**RE: Drainage Report and Grading and Drainage Plan for Avalon Subdivision (K9/D12)  
Submitted for Preliminary Plat Approval, Engineer's Stamp Dated 3/16/98.**

# **DRAINAGE MASTERPLAN**

## **AVALON SUBDIVISION**

TITLE: AVALON SUBDIVISION, UNIT II  
PHASE TWO GRADING & DRAINAGE PLAN

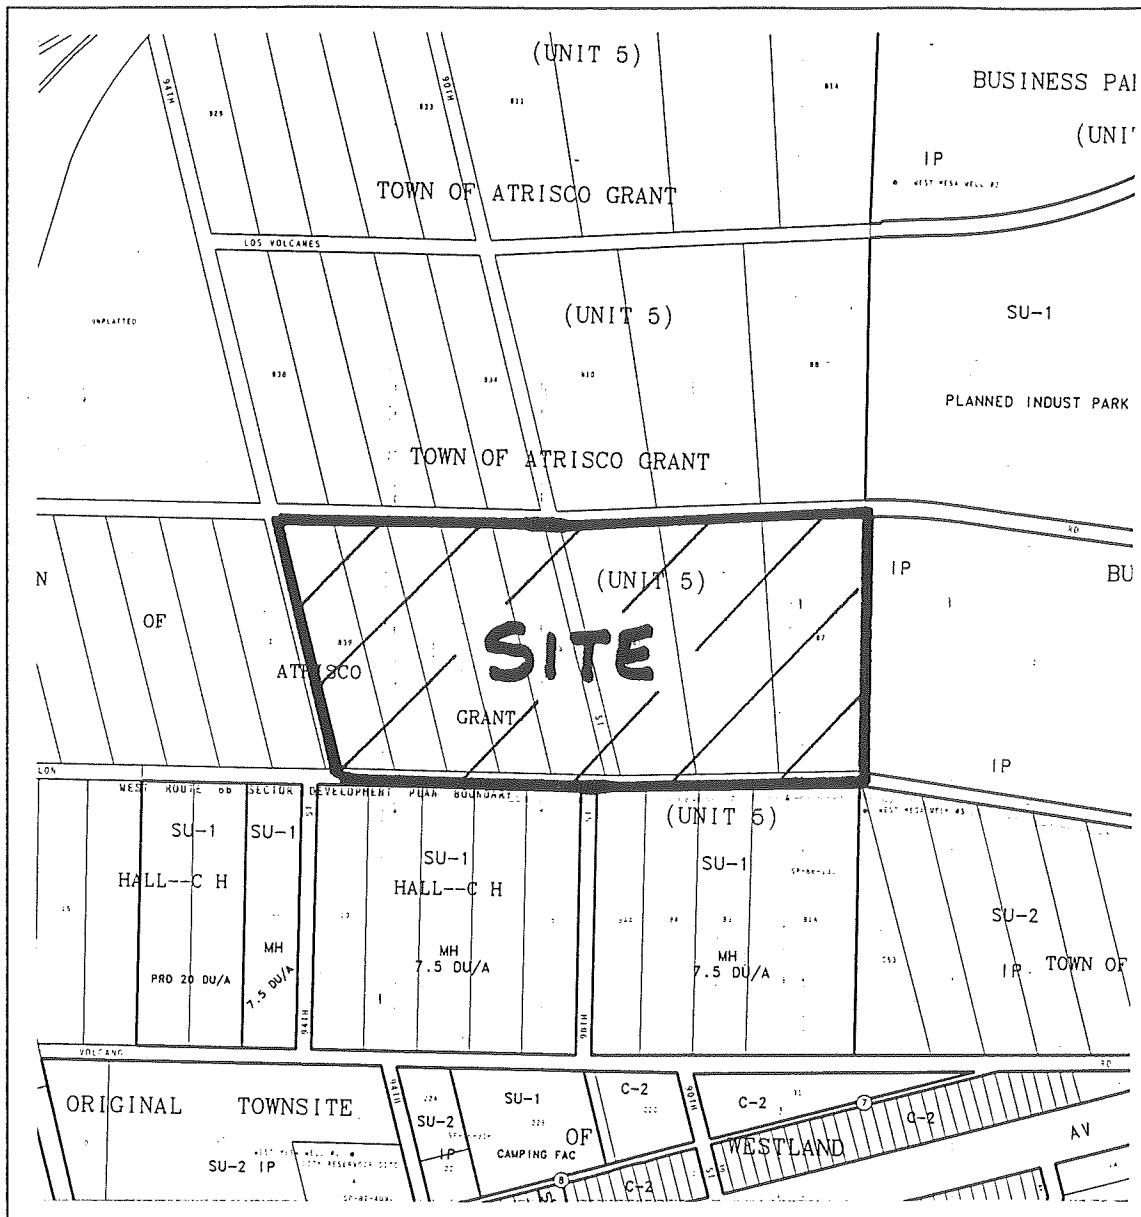
*off site  
easements*

*agreed  
convert to  
ponds*
